General Information

Western Star
Service BulletinConstellation
Heritage
> 4700 Models4800 Models
4900 Models
5700 Models5900 Models
6900 Models

Fig. 1, Marking the Adapter Angle

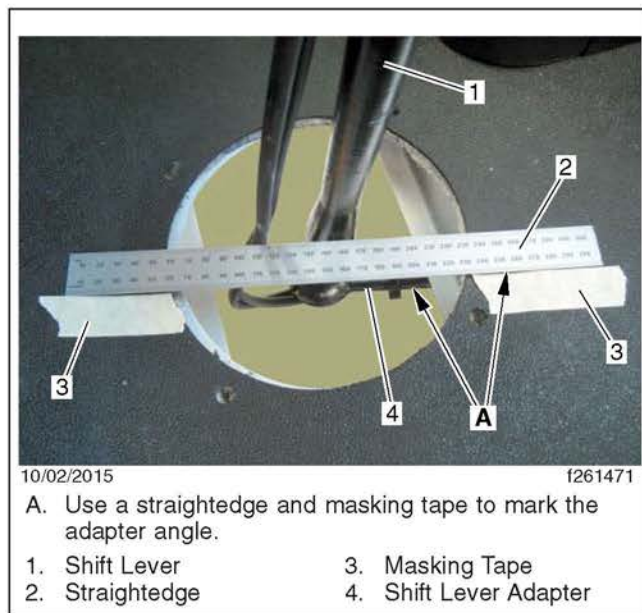
4. Using a straightedge and masking tape, mark the angle of the shift lever adapter on the cab floor. See [Fig. 1](#).
5. Remove the wiring tie strap from the shift lever adapter. See [Fig. 2](#).

- 10.3 Orient the adapter to the proper angle, using a straightedge and the previously placed masking tape as a guide. See [Fig. 1](#). The shift knob should point directly forward.
